Subject: Exelon Nuclear Texas Holdings, LLC
Victoria County Station
Response to Request for Additional Information Letter No. 01
NRC Docket No. 52-042

- RAI Question 02.05.01-1 Basic Geologic and Seismic Information

RAI Question 02.05.01-1

Figure 1: Profiles 4 through 8 from SSAR Figures 2.5.1-50b and 2.5.1-50c shown with no vertical exaggeration (i.e., 1:1 horizontal to vertical scale). Zones of potential deformation indicated in this figure are the same as in the original SSAR figures.

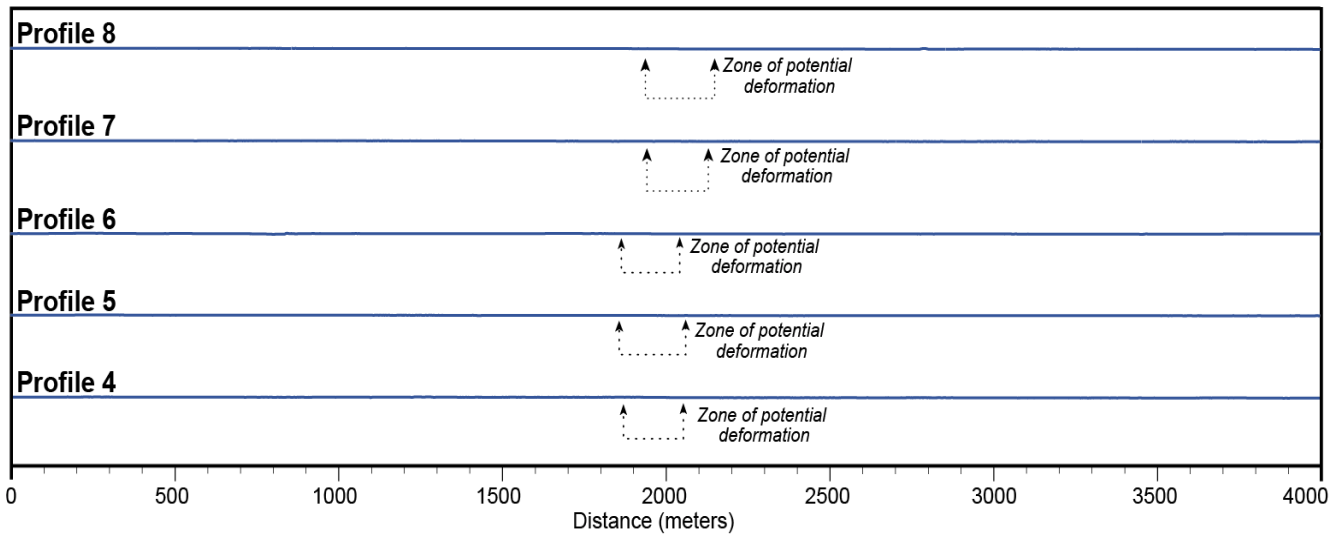
In FSAR Section 2.5.1.2.4.2.3 and 2.5.3.4.2 you describe growth fault D that breaks and offsets the current land surface and is located approximately 509 ft. to the southeast of the VC power block building. Growth fault E also breaks the surface but is farther away from the power block building. In accordance with Appendix C.2.4 and Regulatory Position 1.4 of Regulatory Guide 1.208, please provide the following information about the faults.

- a. Clarify the distance from Fault D to the planned power block area.
- b. Provide additional details on the movement history of growth fault D, including a justification for your assumption that the slip is continuous.
- c. Provide additional details on the calculation of slip-rate.
- d. Provide a discussion about your investigation on the age of the current land surface and the soil sequences over the surface expression of the fault.
- e. Provide a discussion about estimates of age of fault activity based on soil horizon evolution or soil catenas across the fault zone (McAlpin et al., 2009, p 251).
- f. Provide a discussion about the possible fault scarp at the surface. Include an estimate of time since last movement based on a fault scarp degradation analysis (McAlpin et al., 2009, p 247).

The variation in topography is so minor across the zone of surface deformation associated with both growth faults D and E (Figure 1) that the soils on the deformed surface would not be subjected to different rates or styles of soil-forming processes. Because different rates or styles are necessary to form a soil catena, variations in soil characteristics across the zone are not expected. The age of soil horizons on the tilted land surface are also not thought to be able to constrain the timing of deformation associated with the growth faults, because soil development is not likely to have been impacted by the formation of the subtle monoclinial folding or tilting (e.g., steepest slopes of < 0.5°). However, an analysis of soil maps for the site area (Miller 1982; USDA 2010) is described below.

As discussed above, there is no observed fault scarp associated with either growth fault D or E. Instead, the faults are associated with broad, low-amplitude, monoclinical folding and/or tilting (Figure 1). As such, it is not appropriate or feasible to use diffusion dating, a method premised on the rate of erosional degradation of a scarp formed by discrete surface fault rupture, to estimate the age of the surface deformation. The primary reasons why diffusion dating and other methods cited in the reference provided in the RAI question (McCalpin 2009) are not appropriate include:

- There is no fault scarp. The topographic relief on the Beaumont surface above the growth faults was produced by long-wavelength tilting or folding, not erosion of a surface fault scarp, thus violating the key premise of the diffusion dating technique;
- The slope of the monoclinical folding and tilting is less than 0.5° , and is thus very gentle and not appropriate for the linear-plus-cubic diffusion method; and
- There are no reliable estimates of the diffusion constant for the type of Pleistocene sediments that comprise the Beaumont Formation and the climate of southern Texas; thus, it would not be possible to obtain reliable age estimates from the diffusion dating technique even if the Beaumont surface was deformed by discrete surface faulting.
